APPLICATION NO PA/2015/0161

DEVELOPMENT Listed building consent to erect a two-storey extension (resubmission of PA/2014/0880)

LOCATION Cleatham House Farm, unnamed road through Cleatham from B1400 to B1398, Manton

SUMMARY RECOMMENDATION Refuse consent

PA/2015/0160 & PA/2015/0161 Proposed Elevations
Not to scale

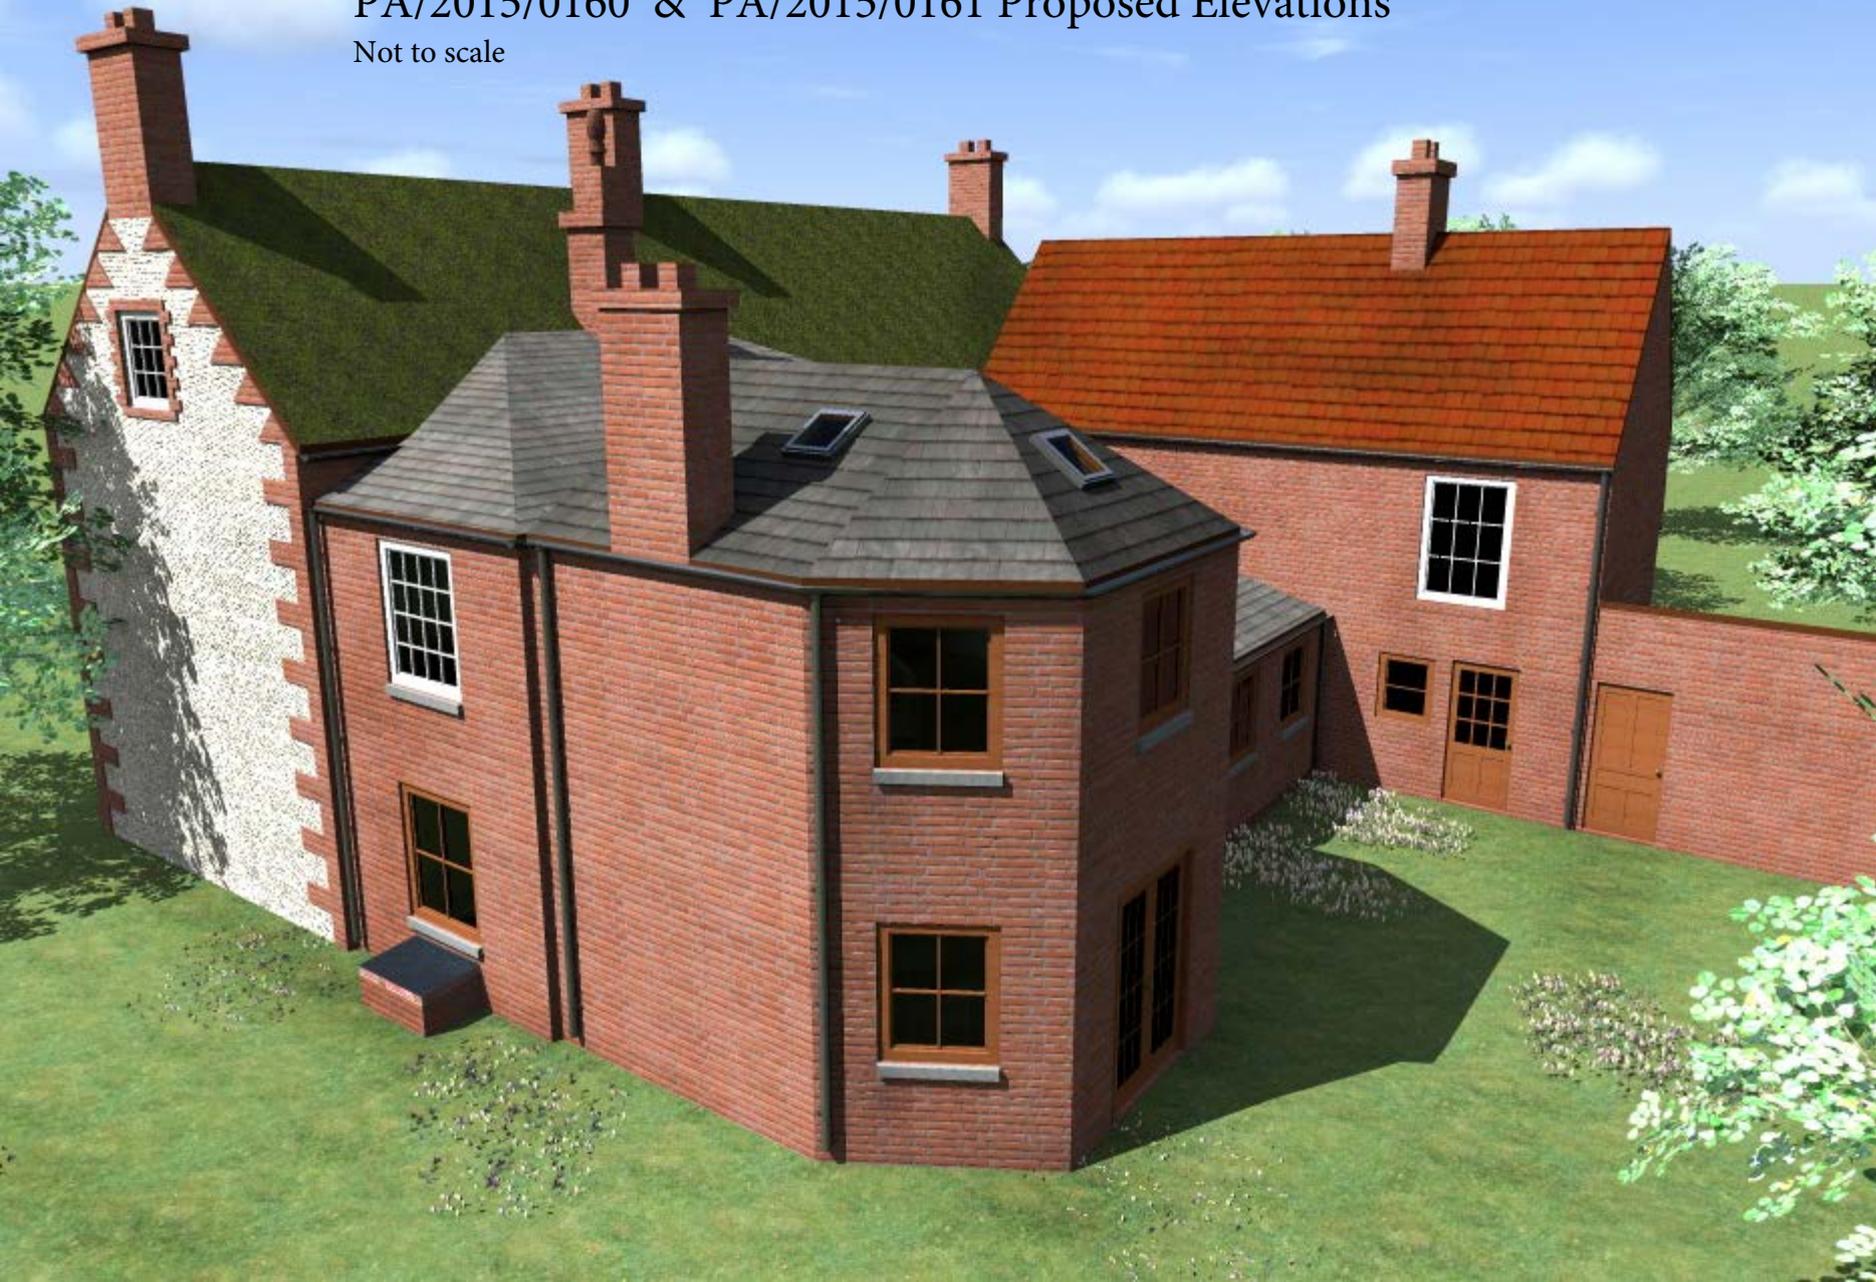
Where this application fails is the relationship between the existing building and the proposed extension. To the south-eastern corner of Cleatham House Farm is another Victorian extension which projects out by almost 3.5 metres. This existing extension has a hipped roof which faces towards the proposed gable; this hip runs into the proposed gable. Due to this arrangement it is clear that the proposed extension is a later addition which does not integrate into the existing building, instead it stands alone as an unplanned addition. Given the awkward arrangement between the proposed extension and the existing building it will appear as an incongruous addition, which detracts from the character and appearance of the building. This impact is accentuated by the prominence of the gable in the context of the property's attractive side and front elevations at the entrance.

Concerns are also raised regarding the east-facing elevation of the proposed extension, which is a half hexagon with a hipped roof. It should be noted that this arrangement was

approved at ground-floor level by an earlier application; however, its prominence is increased by the first-floor addition. This design feature is uncharacteristic of the listed building and the Cleatham House Farm complex; it introduces a new design element and unbalances the extension which has a gable on its opposite elevation. This design is considered to further highlight the proposed extension as an uncharacteristic addition to the existing building. It should be noted that this element will be highly prominent from the footpath to the rear of the property.

1.
The proposed development is found to form a discordant feature and be visually incongruous and as such is contrary to local plan policies DS5 and SPG1, policy CS5 of the Core Strategy and section 7 of the National Planning Policy Framework.
- 2.

The proposed development is found to cause significant harm to the visual aesthetic of the grade II listed building and not enhance the building's fabric or character and as such is contrary to local plan policy HE5, policy CS6 of the Core Strategy and section 12 of the National Planning Policy Framework.
